ADVISORY WIRE

REFERENCE NO:	AW700-28-0469	INFORMATION TYPE:	Maintenance Operational
ATA:	28-41	EFFECTIVITY:	Global Express 9002 to 9153
SUBJECT:	Fuel Management and Quantity Gauging Computer Tray Connector Inspection		Global 5000 9127 to 9411, 9417 to 9431, 9998
			Global Express XRS 9159 to 9429
			Global 5000 feat. Bombardier Vision Flight Deck 9386, 9401, 9445 to 9571,9574
			Global 6000 9313, 9381, 9432 to 9572

Figure 1: FMQGC tray connector (A47P1).

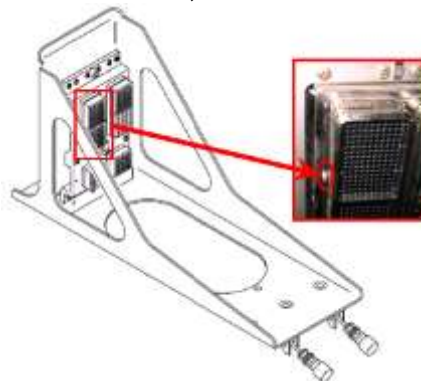
During installation of the FMQGC on the aircraft production line, it was reported that a screw installed on the insert fitting at the rear of the FMQGC tray connector was excessively long and protruding on the opposite side of the connector (A47P1--refer to Figure 1). The screw is used to maintain the connector blocks in the connector shell and, on certain aircraft, is also used as a shield termination.

A longer screw caused a fouling condition with the backside of the FMQGC and prevented the unit from being fully inserted into its mounting tray. The extent of the physical damage observed on the FMQGC was limited to minor paint damage (screw print) on the external casing.

Figure 2: View looking inboard of FMQGC connector tray (A47P1).

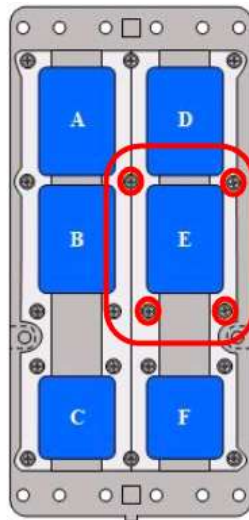
Bombardier has conducted an investigation which has revealed an inconsistency with the assembly manual, resulting in having longer screws installed surrounding connector block E (A47EP1) of the FMQGC tray connector (refer to Figure 2).

In order to eliminate the potential fouling condition during aircraft production, the assembly manual has been revised starting at A/C S/N 9573 to install a shorter screw on the connector assembly. Bombardier has released an In-Service Modsum (ISMS--ref. 1.1) which consists of an inspection of the FMQGC tray connector (A47P1) for any protruding screws.

Bombardier recommends that Operators inspect all the screws surrounding block E of the FMQGC connector (A47P1) for possible fouling condition, in accordance with the ISMS (ref. 1.1). Following the visual inspection, should the Operator confirm a fouling condition, the applicable screws should be replaced with a shorter one as instructed in the ISMS.
